AMENDMENT DRAWING

SUPERSEDES 100-EP405T0

Drawing Title: ENLARGED ELECTRICAL ROOM C PLAN - POWER TEMPORARY

Project Title: VA PUGET SOUND HEALTH CARE SYSTEM UPGRADE SEATTLE ELECTRICAL DISTRIBUTION FROM 5kV TO 15kV

ENLARGED MAIN SWITCHGEAR ROOM C - TEMPORARY T1

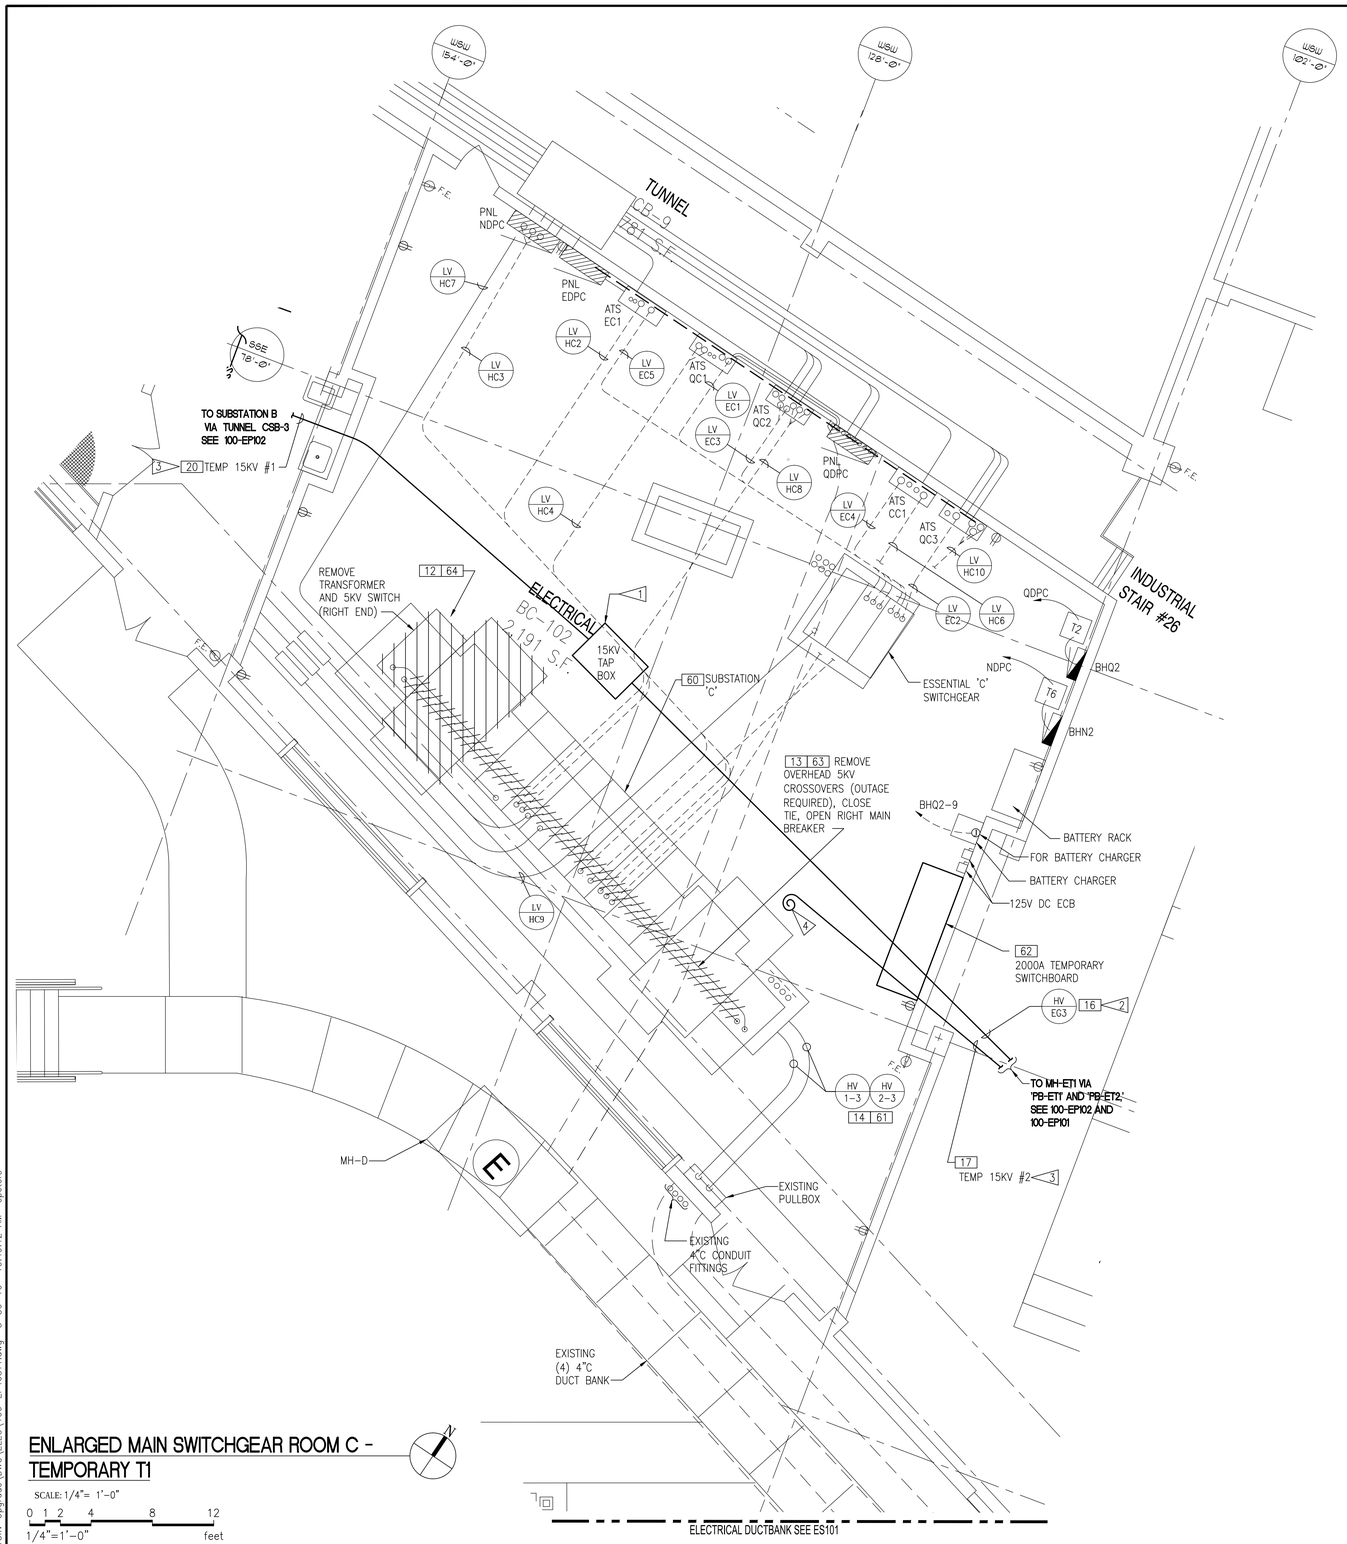
1. PROVIDE 15KV TAP BOX.
2. PROVIDE FEEDER AS SHOWN.
3. TEMPORARY FEEDERS SHALL BE ARMORED CABLES, UNLESS OTHERWISE NOTED.
4. COIL TEMP FEEDER FOR FUTURE CONNECTION.

ENLARGED MAIN SWITCHGEAR ROOM C - TEMPORARY T2

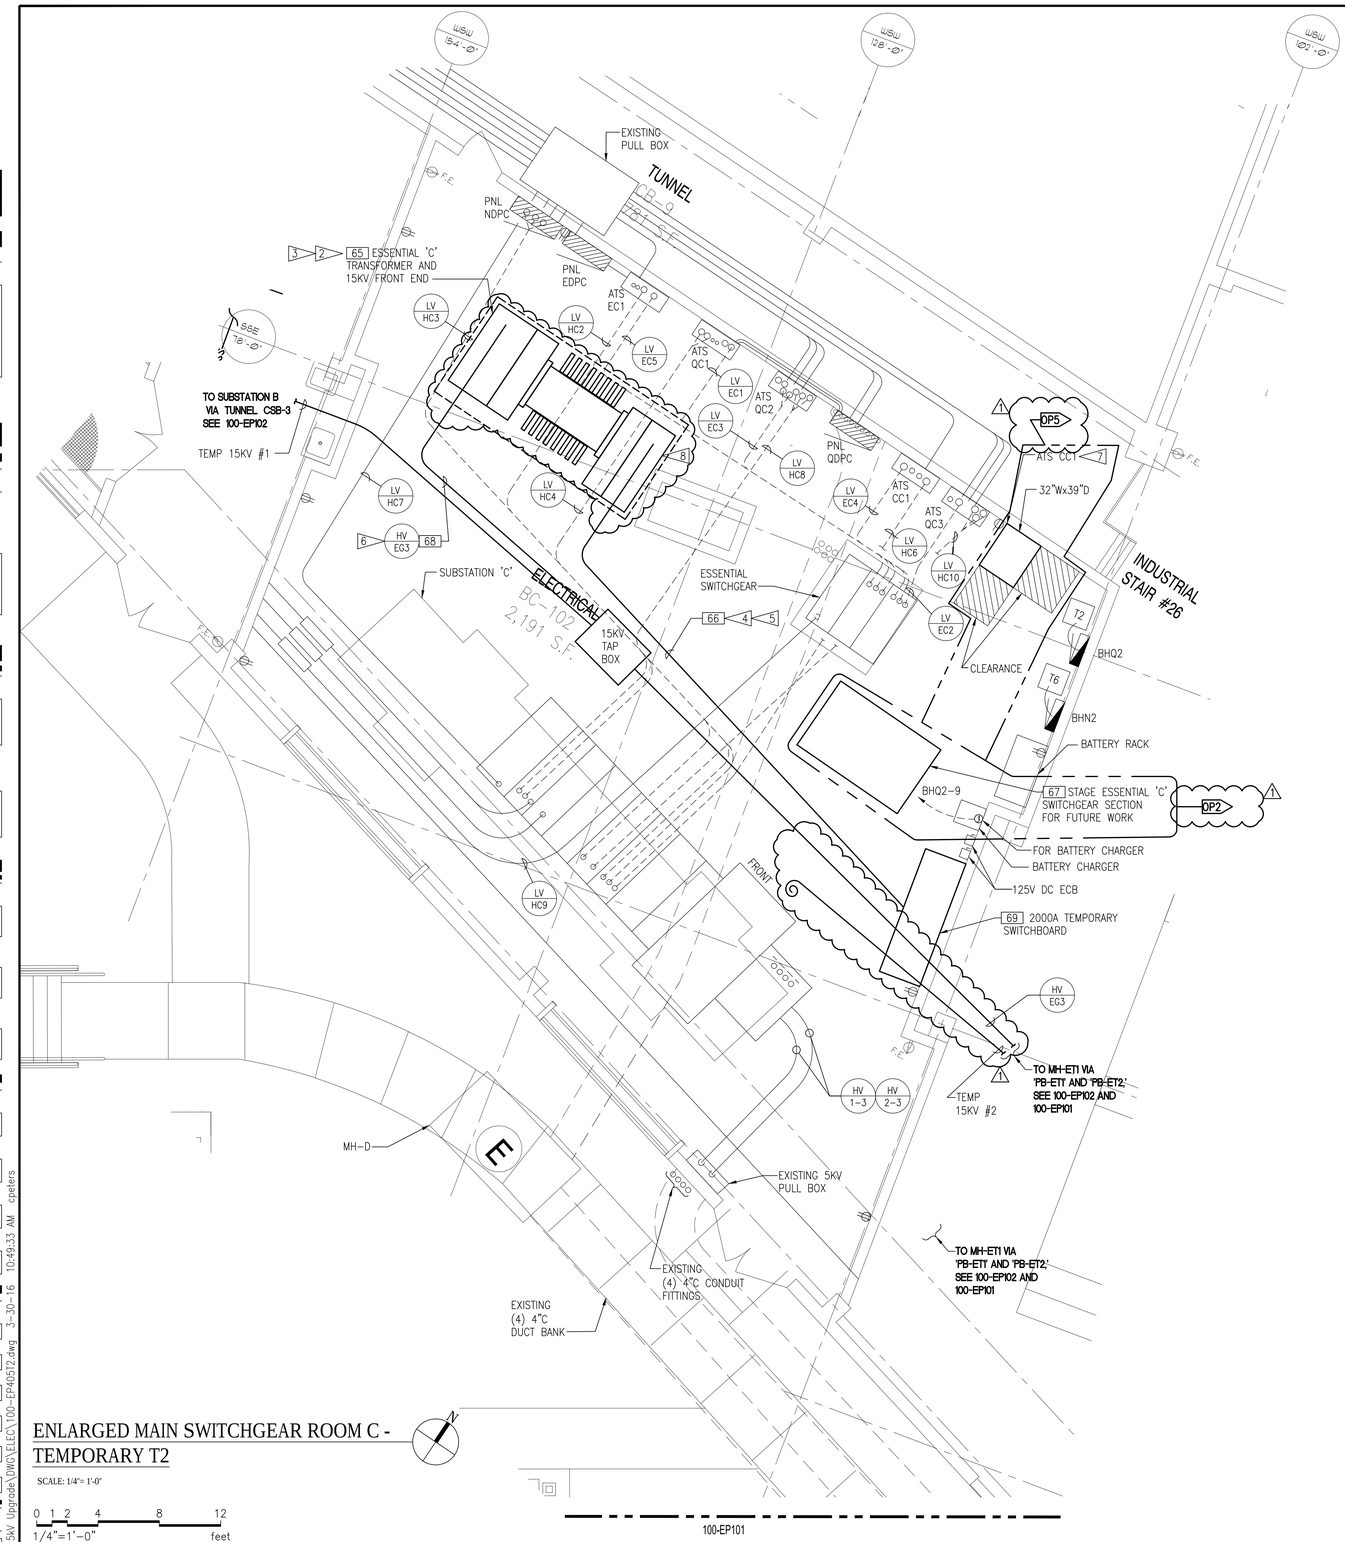
1. PROVIDE 15KV ESSENTIAL SWITCHGEAR.
2. PROVIDE TRANSFORMER AS SHOWN.
3. COORDINATE HOUSE-KEEPING PAD WITH STRUCTURAL.
4. PROVIDE TEMPORARY FEEDERS.
5. TEMPORARY FEEDERS SHALL BE ARMORED CABLES, UNLESS OTHERWISE NOTED.
6. PROVIDE FEEDER AS SHOWN.
7. PROVIDE 400A/3-POLE, 480V AUTOMATIC TRANSFER SWITCH WITH BYPASS ISOLATION.
8. REVISED SWITCHGEAR POSITION AND FEEDER TERMINATION.

ENLARGED MAIN SWITCHGEAR ROOM C - TEMPORARY T3

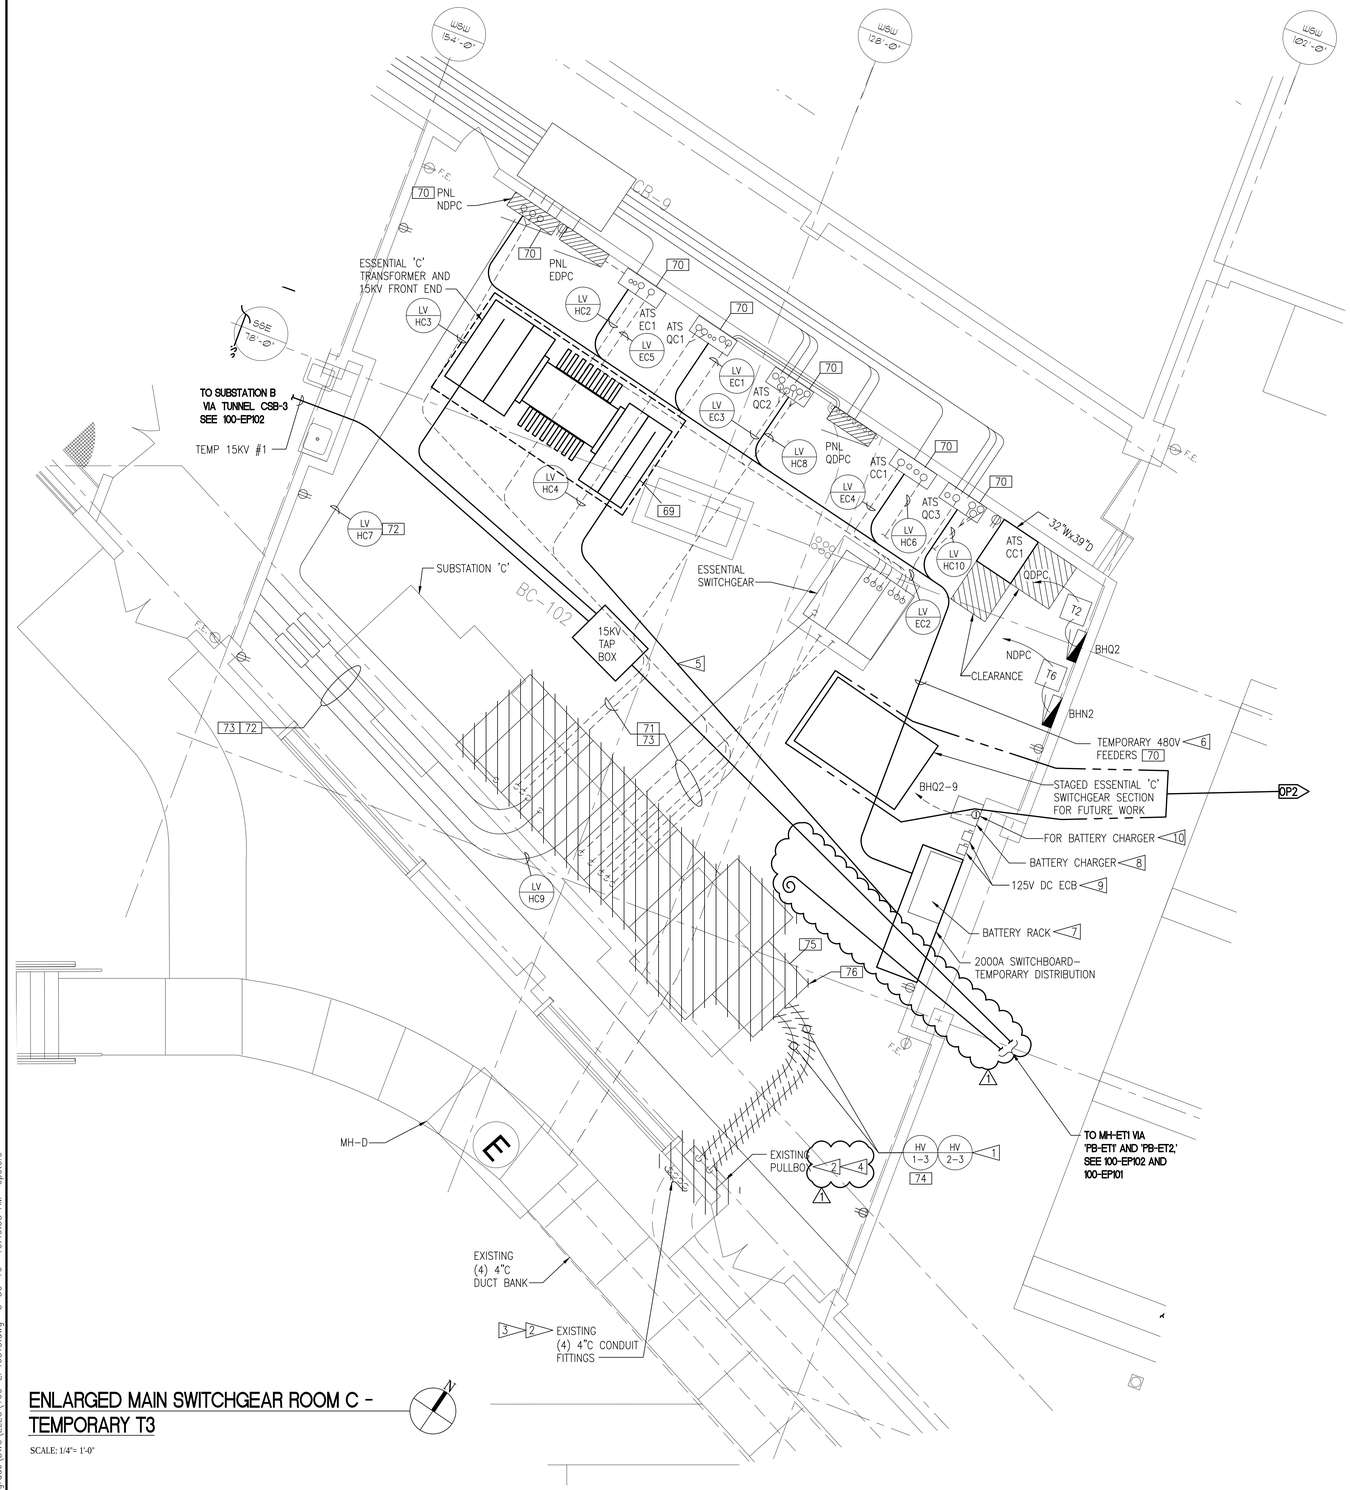
1. REMOVE CONDUITS AND CABLES.
2. REPLACE 5KV FEEDERS WITH 15KV FEEDERS.
3. REMOVE CONDUIT FITTINGS AND INTERCEPT CONDUITS AND EXTEND TO PULL BOX PB-CT1. REFER TO 100-EP405-T6 FOR PULL BOX REQUIREMENTS.
4. REPLACE EXISTING PULL BOX WITH NEW. REFER TO 100-EP405T6 FOR PULL BOX REQUIREMENTS.
5. PROVIDE MC CABLE (6) 1-4/C, 500KCMIL. PROVIDE EQUIPMENT GROUNDING PER NEC 330.108. PROVIDE SUPPORT AS REQUIRED.
6. PROVIDE MC CABLE EQUIVALENT TO FEEDER SCHEDULE FOR DISTRIBUTION EQUIPMENT CONNECTION.
7. REMOVE BATTERY RACK.
8. REMOVE BATTERY CHARGER. MAINTAIN EXISTING EQUIPMENT RACK FOR RE-USE.
9. EXISTING ENCLOSE CIRCUIT BREAKER TO RE-USED.
10. MAINTAIN EXISTING CIRCUIT FOR BATTERY CHARGER FOR RE-USE. SEE DWG 100-EP405T4 FOR ADDITIONAL WORK.

ENLARGED MAIN SWITCHGEAR ROOM C - TEMPORARY T4

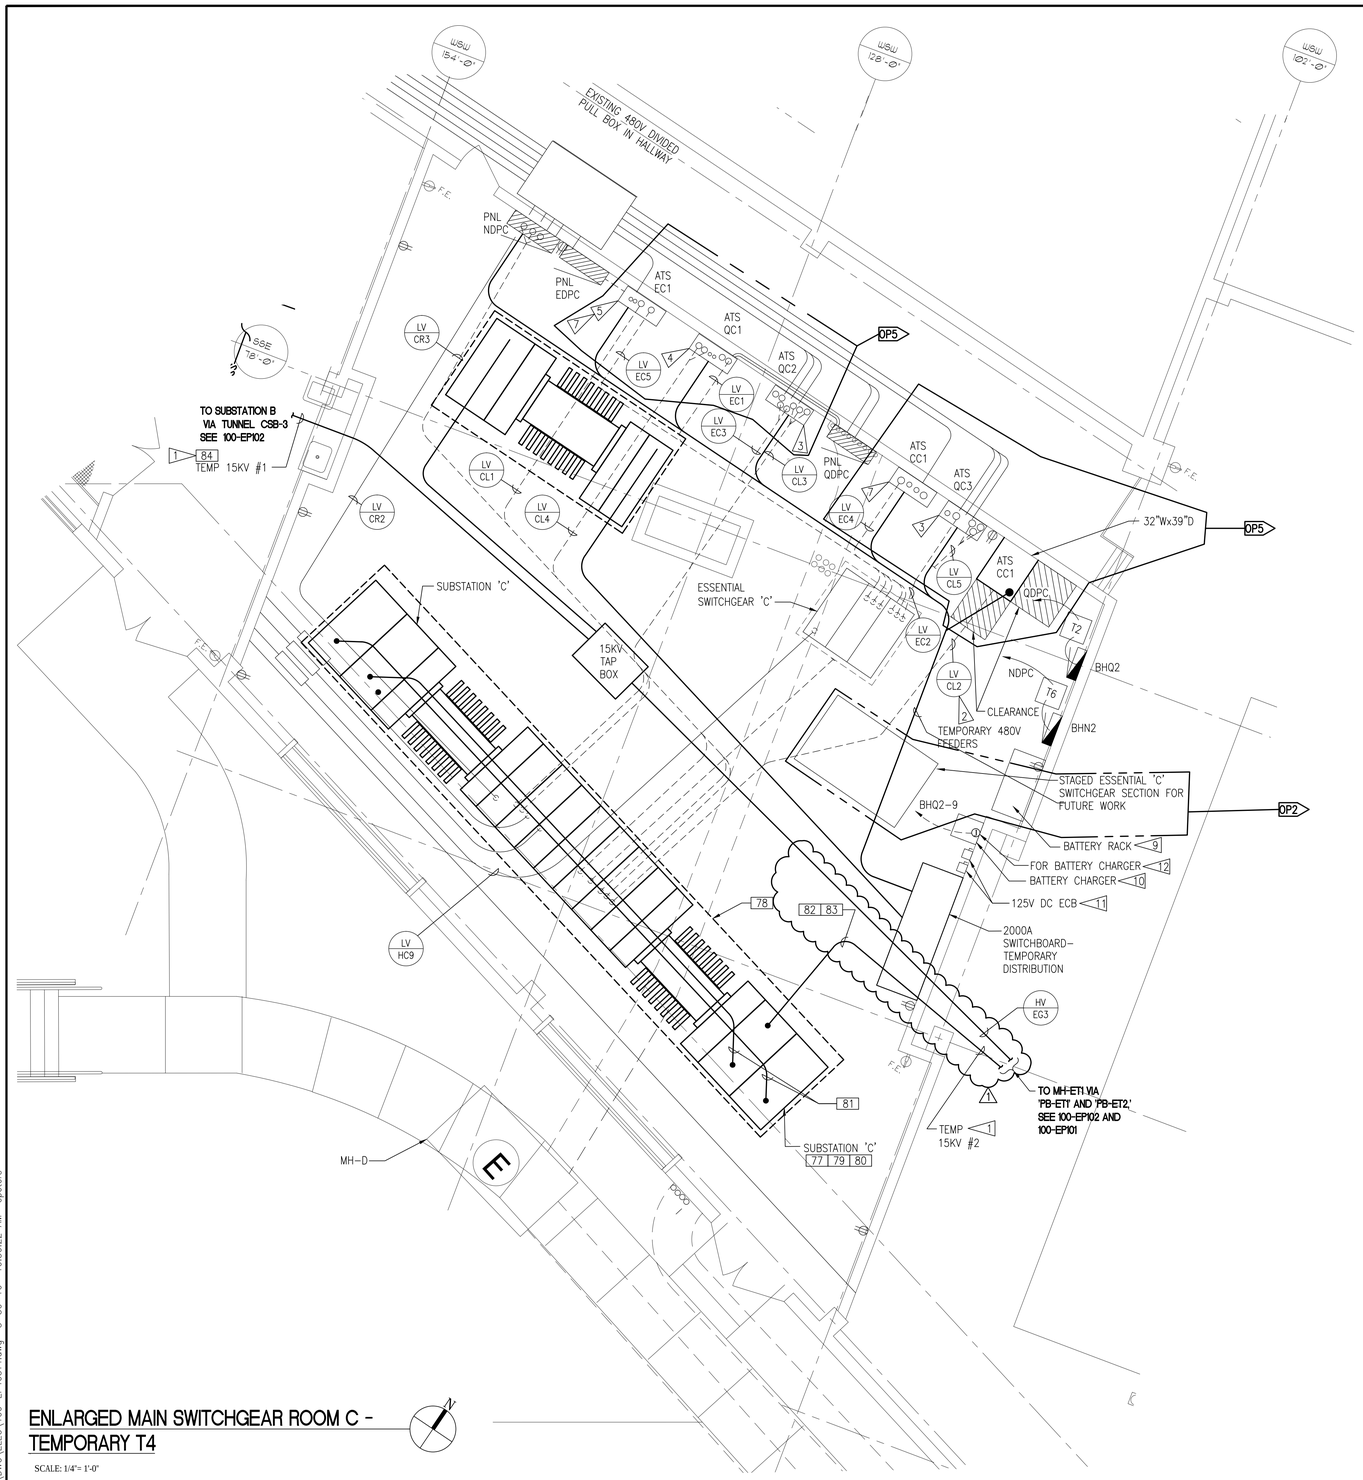
1. PROVIDE ARMORED CABLE EQUIVALENT TO HV EG3.
2. PROVIDE FEEDER AS SHOWN.
3. REPLACE 800A, 3-POLE, 480V AUTOMATIC TRANSFER SWITCH INTERIOR ASSEMBLY IN EXISTING CAN. PROVIDE CONTINUOUS LOCKABLE TYPE PIANO HINGE DOOR. COORDINATE SHUTDOWN WITH VA PRIOR TO REPLACING ATS. NEW ATS SHALL BE OPERATIONAL PER EXISTING CONDITIONS UPON PROJECT COMPLETION.

4. REPLACE 400A, 3-POLE, 480V AUTOMATIC TRANSFER SWITCH INTERIOR ASSEMBLY IN EXISTING CAN. PROVIDE CONTINUOUS LOCKABLE TYPE PIANO HINGE DOOR. COORDINATE SHUTDOWN WITH VA PRIOR TO REPLACING ATS. NEW ATS SHALL BE OPERATIONAL PER EXISTING CONDITIONS UPON PROJECT COMPLETION.

5. REPLACE EXISTING ATS WITH 400A, 4-POLE, 480Y/277V TRANSFER SWITCH WITH BYPASS ISOLATION. COORDINATE SHUTDOWN WITH VA PRIOR TO REPLACING ATS. NEW ATS SHALL BE OPERATIONAL PER EXISTING CONDITIONS UPON PROJECT COMPLETION.

6. NOT USED
7. MAINTAIN ATS CC1 FOR TEMPORARY CONNECTION TO ATS EC1 DOWNSTREAM PANEL SHALL BE OPERATIONAL DURING ATS EC1 REPLACEMENT.
8. NOT USED.
9. COORDINATE SPACE REQUIREMENTS WITH SWITCHGEAR PROVIDER.

10. PROVIDE BATTERY CHARGER. INSTALL IN EXISTING EQUIPMENT RACK. PROVIDE CONNECTIONS TO BATTERIES.
11. CONNECT EXISTING ENCLOSED CIRCUIT BREAKER TO NEW BATTERY RACK.

12. CONNECT EXISTING CIRCUIT AND EXTEND TO NEW CHARGER.

ENLARGED MAIN SWITCHGEAR ROOM C - TEMPORARY T5

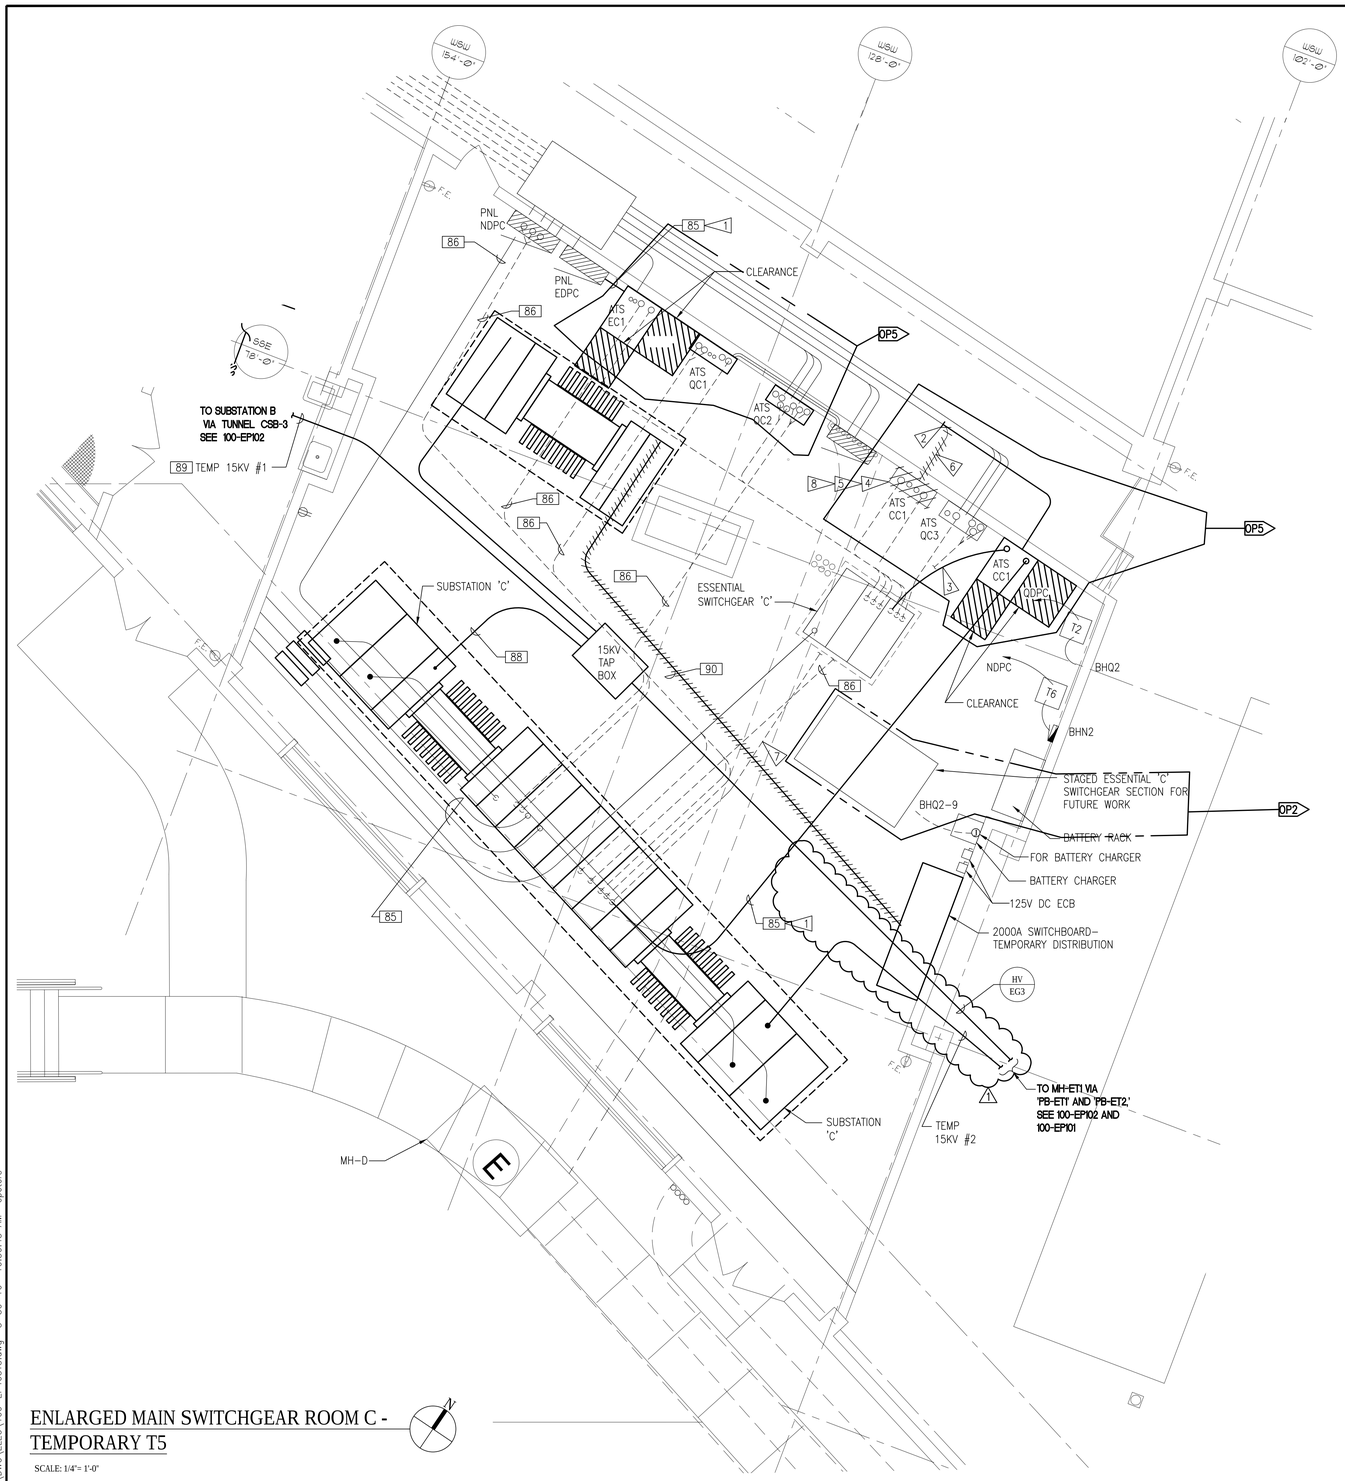
1. PROVIDE 480V FEEDERS, AS SHOWN.
2. INTERCEPT EXISTING FEEDER AND EXTEND TO NEW ATS LOCATION.
3. PROVIDE TEMPORARY FEEDER TO ATS AS SHOWN.
4. INTERCEPT EXISTING CONTROL WIRES AND EXTEND TO NEW ATS LOCATION.
5. DISCONNECT AND REMOVE EXISTING ATS. REMOVE UN-USED CONDUIT FLUSH TO FLOOR AND CAP.
6. REMOVE AS SHOWN.
7. REMOVE CONDUCTORS AND ABANDON CONDUITS.
